Huguet-Kroman RUE
PLN51228 RUE

Staff Report

Project Huguet-Kroman RUE
File No. PLN51228 RUE
Date February 25, 2021
To City of Bainbridge Island Hearing Examiner
Project Manager Annie Hillier, Associate Planner

Request	The request is for a reasonable use exception (RUE) to allow development of a single-family residence and garage within a wetland buffer. Onsite wetland buffer enhancement is proposed to compensate for impacts to the critical area.
Address	**no situs address**, Bainbridge Island, WA 98110
Tax Assessor #	34260240332007
Environmental Review	The project is exempt from the State Environmental Policy Act (SEPA) under WAC 197-11-800(6)(a).

Figure 1 – Site Plan

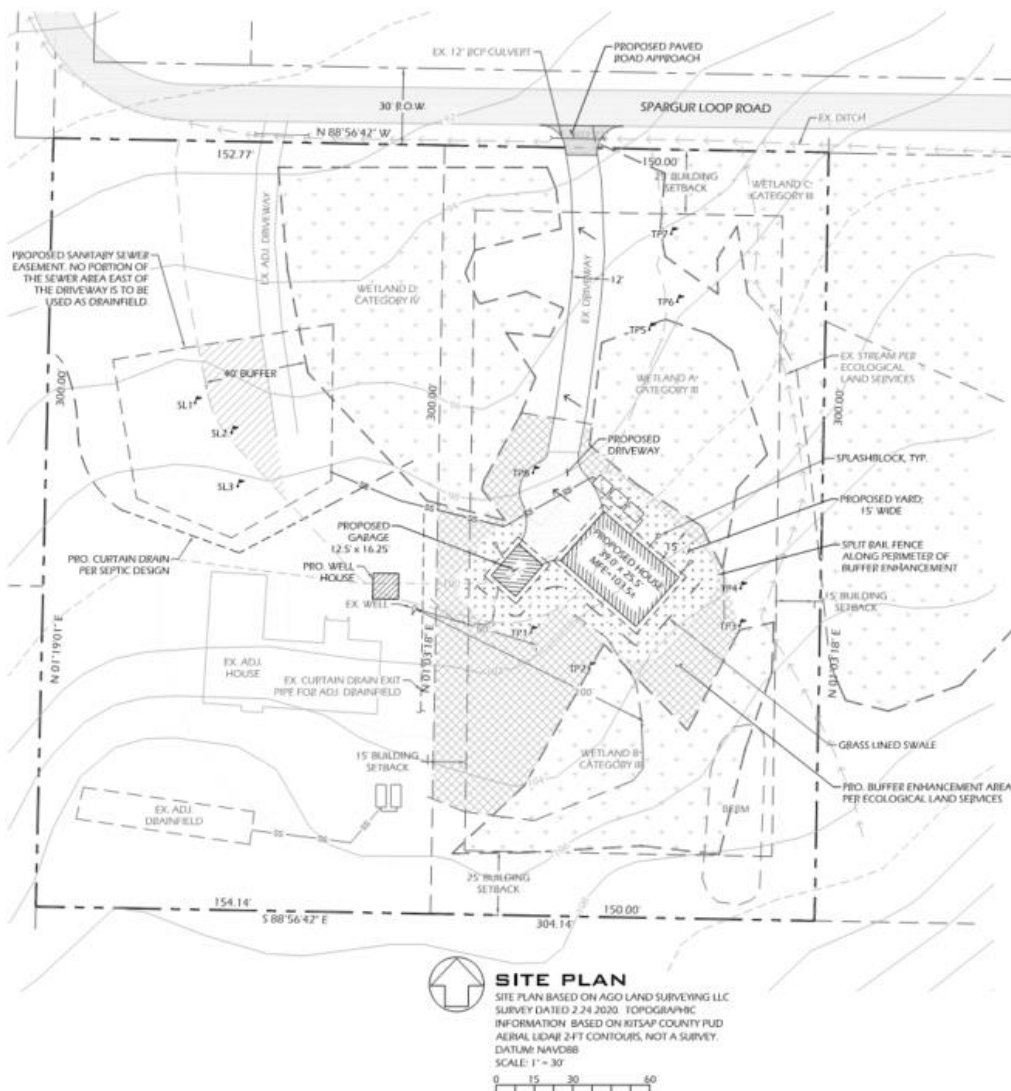
The proposal is for a single-family residence (SFR) and garage on a lot encumbered with wetlands and wetland buffers. An existing driveway will be utilized to access the SFR, which is proposed in an area currently consisting of mowed grass and invasive blackberries. The septic drainfield is proposed on the adjacent lot to the west, which is under the same ownership, because this is the only area within the vicinity with adequate soils to accommodate a drainfield. The area of the proposed drainfield is also located within a wetland buffer. Mitigation in the form of buffer enhancement is proposed on the subject property, to compensate for impacts to the critical areas from both the drainfield and the SFR/garage. The applicant requests a reasonable use exception (RUE) to develop the property and install the septic drainfield in accordance with BIMC 16.20.080, as the parcel is completely encumbered by wetlands and wetland buffers.

Staff response: The proposal includes a detached garage. Although the application does not specify whether it is a 1-car or 2-car garage, there appears to be adequate room for 1 vehicle to park within the driveway if a 1-car garage is proposed.

Figure 3 – The subject property is encumbered by 4 wetlands and their corresponding buffers.

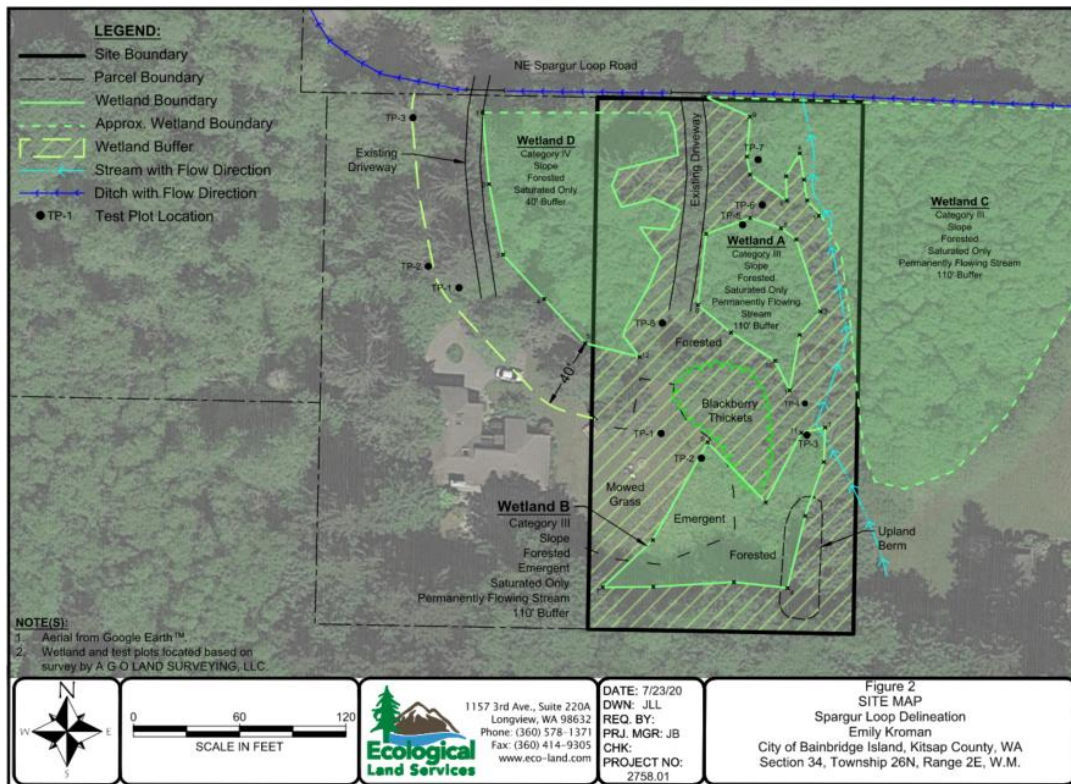
The wetland delineation report and mitigation plan submitted with the application (Exhibit 9) identifies 4 wetlands on the subject property. A small, unmapped stream is also identified on the east side of the property. According to the rating forms, Wetlands A-C are category III wetlands and Wetland D is a category IV wetland (note: page 2 of the report states that all wetlands are category III, but this appears to be an error). The buffers extending between these wetlands completely encumber the site. A buffer from the small stream is not identified; restrictions on the property related to an unmapped stream buffer would be the same as for the wetland buffers which overlap in the same area, so additional information about the unmapped stream was not requested. All development is located outside of the stream.

Staff response: There are three category III wetlands with 110' buffer and one category IV wetland with a 40' buffer onsite.

Figure 4 – Mitigation proposal

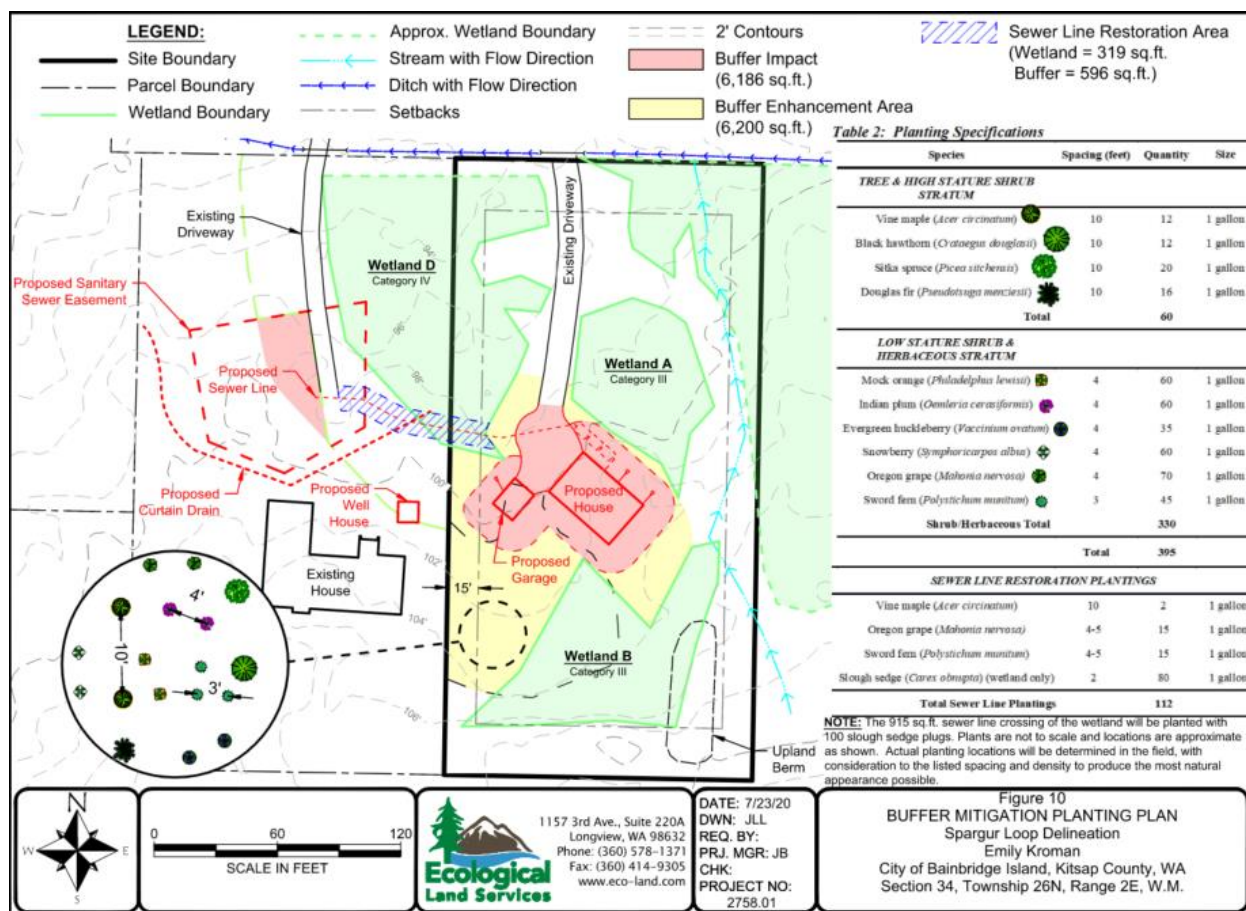
Staff response: Although there are no prescriptive mitigation requirements for wetland buffers, the mitigation plan is required to contain goals and objectives that are related to the functions and values of the original critical area, in accordance with BIMC 16.20.180.G.3.b. As described in the critical areas report, the existing wetland buffer "is composed of dense mowed grasses and herbaceous weeds that have some ability to improve water quality...It currently provides no habitat or wetland protection functions because it lacks woody vegetation cover."

The buffer enhancement plan contains goals and objectives related to improving water quality, wildlife habitat, and wetland protection. These and objectives are described within the “Buffer Mitigation Justification” section of the report. Staff finds that the goals and objectives are based on a qualitative analysis of the existing buffer functions. As such, this criterion is met. However, a final mitigation plan must be provided with the building permit application, in accordance with BMC 16.20.180.G.3.b. The final plan must address the revised septic line, as well as the final building area layout. The City must agree that the final mitigation plan will result in no net loss of critical area function and value prior to building permit issuance. (Condition 5)

Note: The septic drainfield is proposed on the adjacent lot, within the category IV wetland buffer that extends onto both parcels. Initially staff indicated to the applicant that a separate critical areas permit would be required to install the drainfield, since it is proposed on a separate property. However, because mitigation for impacts from the drainfield will be provided on the subject property and the drainfield is part of a development that requires an RUE, staff finds it acceptable to only require a single land use application for the entire scope of the proposal; nothing would be gained by requiring a second land use application for the drainfield. If the drainfield were proposed within a wetland buffer without an associated RUE, then a critical areas permit would be required.

5. A final mitigation plan shall be provided with the building permit application, in accordance with BIMC 16.20.180.G.3.b. The final plan must address the revised septic line, as well as the final building area layout as a result of the alternatives analysis. The City must agree that the final mitigation plan will result in no net loss of critical function and value prior to building permit issuance, and may require 3rd party review of the final mitigation plan, the cost of which shall be borne by the applicant, should the Director deem necessary.

6. A final planting plan shall be submitted with the building permit application, consistent with the results of the updated mitigation plan.
 7. Lot coverage calculations must be provided with the building permit application.
